Ref: 0536r01v03

**RE: 18 – 20 THE SERPENTINE, BILGOLA BEACH
DEVELOPMENT APPLICATION FOR THE CONSTRUCTION OF A STUDIO AND CAR PARKING STRUCTURE
PARKING DESIGN STATEMENT**

A Pre-lodgement meeting (ref: PLM 2021 / 0305) was held on the 09/12/2021 between the Applicant and Council's representatives with a number of aspects discussed relating to the Proposal including parking design. Council's comments are reproduced below, which are highlighted, for reference.

DRAWING TITLE
FLOOR PLANS + SECTION
PROJECT NO.
2236
SCALE
1:100 @ A1

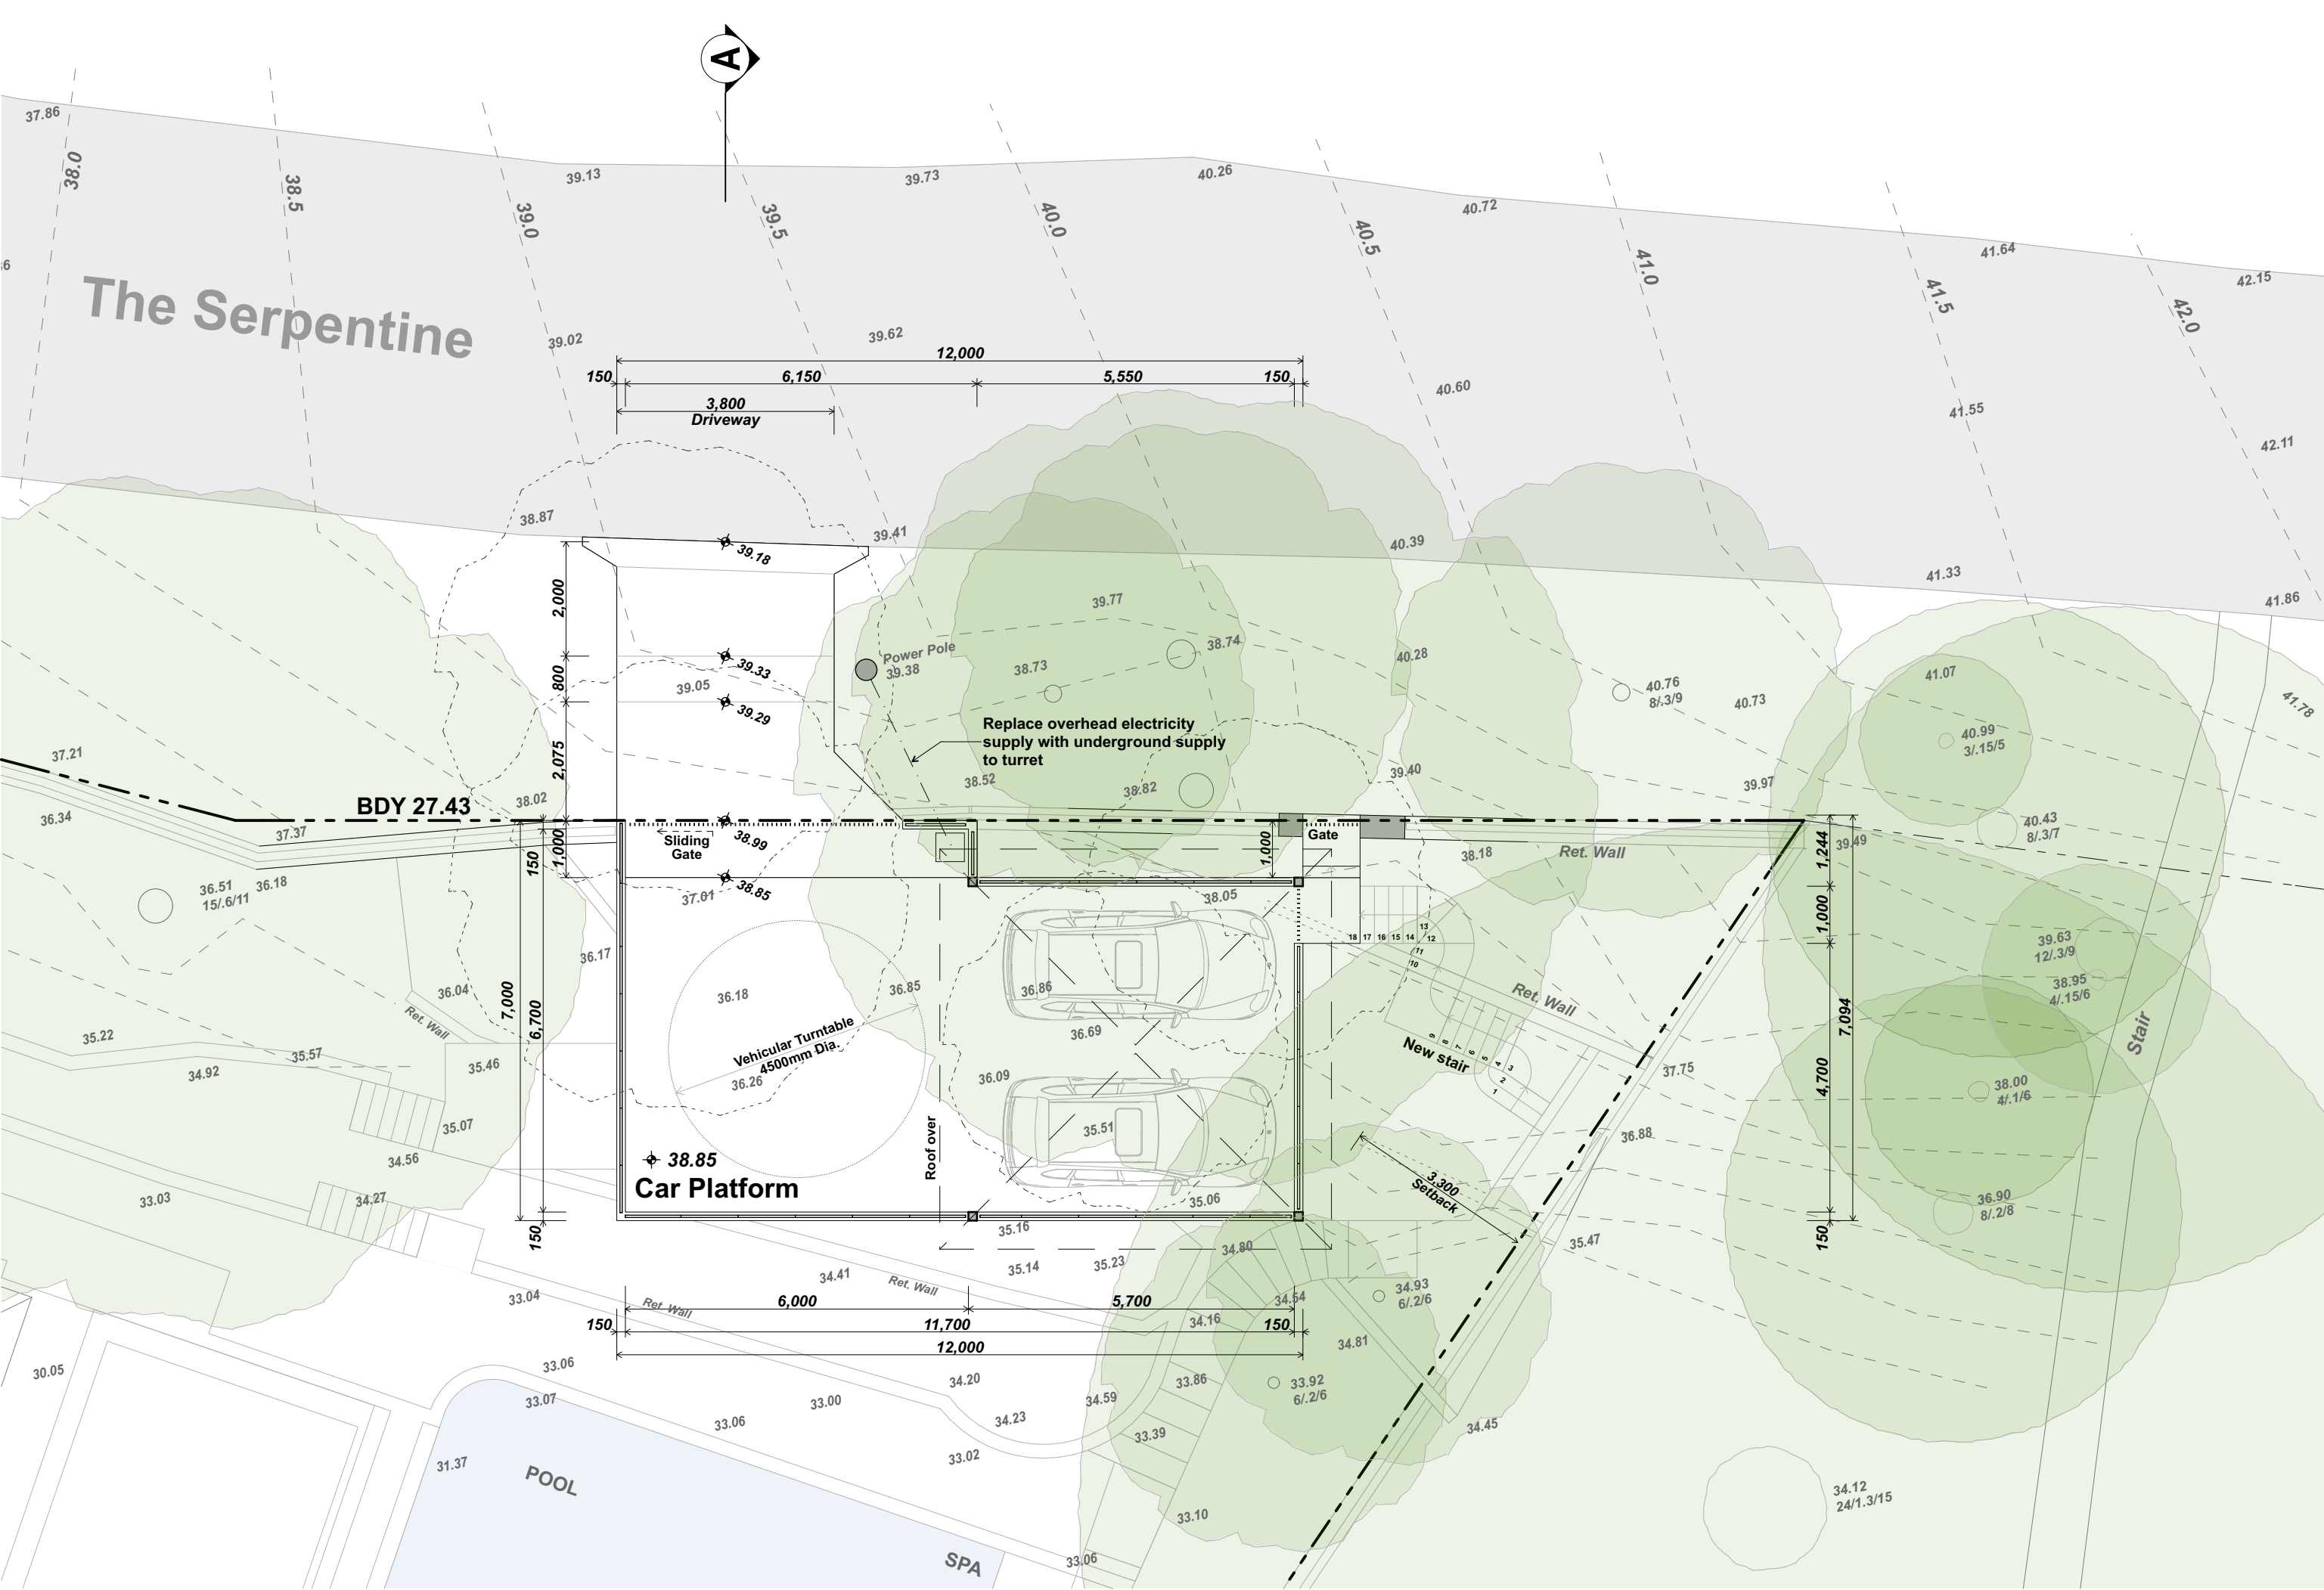
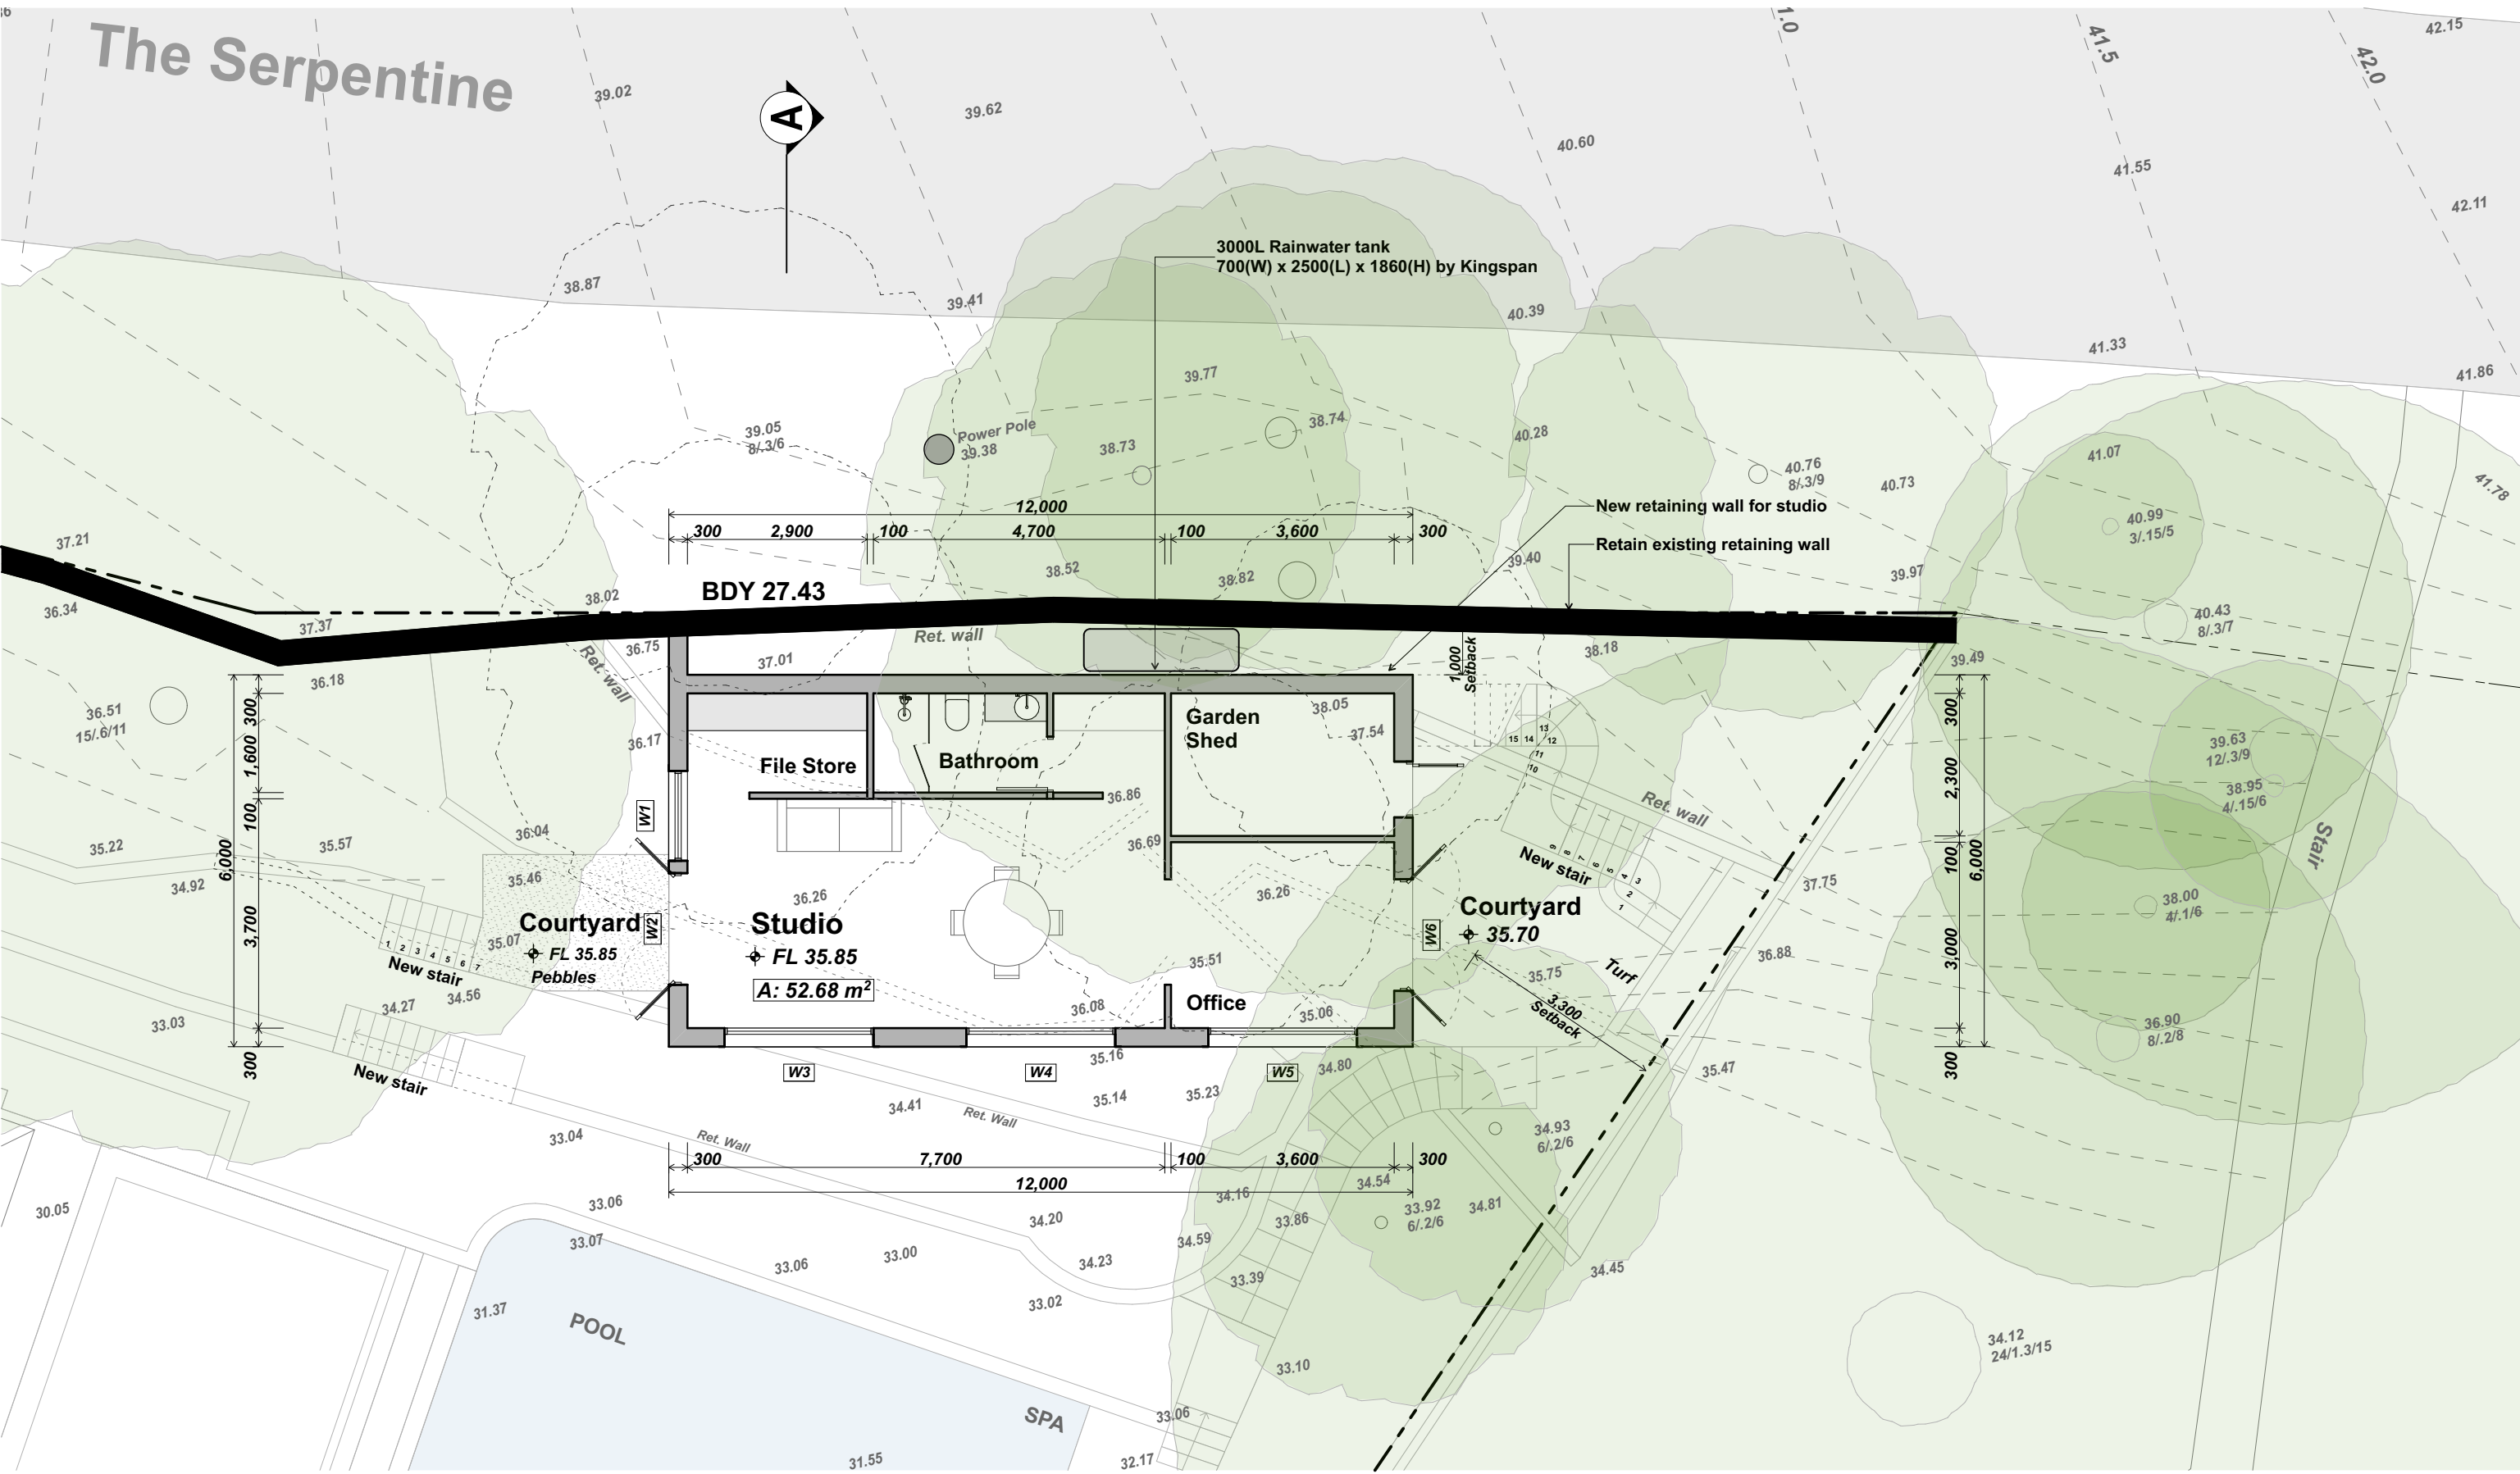
3. The driveway grades must be in accordance with Council's standard drawing A4/330/3 NL. Sections through the proposed crossing are to be submitted demonstrating compliance. The 1:4 Max grade shown on the submitted drawings must include a transition in accordance with the above standard drawing. This will require the proposed parking area to be raised to suit.

5. The proposed off-street parking is to be in accordance with Pittwater Council's Pittwater 21 DCP 2014 Clause B6.3 Off-Street Vehicle Parking Requirements.

- The driveway has a maximum grade of 1 in 7.1 (14%) and therefore satisfies the ramp and driveway grade requirements of AS 2890.1. The maximum grade transition is a sag transition of 1 in 7.1 (14%) which satisfies the requirements of Clause 2.5.3.(d) of AS2890.1.

- The car parking spaces are provided in the form of a double vehicle carport, having an opening width of 5.7 metres, an internal width of 5.7 metres and internal length of 5.7 metres, therefore complying with the relevant requirements of Clause 5.4 of AS 2890.1.

- The proposed double carport is provided with a minimum clear head height of 2.4 metres with satisfies the requirements of Clause 5.3.1 of AS 2890.1.
- A mechanical vehicle turntable is provided in front of the proposed double carport to assist manoeuvrability, given the narrow internal dimension of the car platform. The turntable ensures all vehicles can enter and exit the site in a forward direction.

- The turntables allow for a 6.0 metre clearance diameter and can accommodate vehicles up to a B99 Design Vehicle of length 5.2 metres, per Appendix A of AS 2890.1.. The internal diameter of the turntable itself will be dependent on the product selected by the client however, it is expected to be in the order of 4.8 metres.

- As shown by the architectural drawings included as **Attachment 1**, barriers are provided along the perimeter of the car parking platform. The barriers would not have any impact on driver's sight line to the northeast and to the southwest.
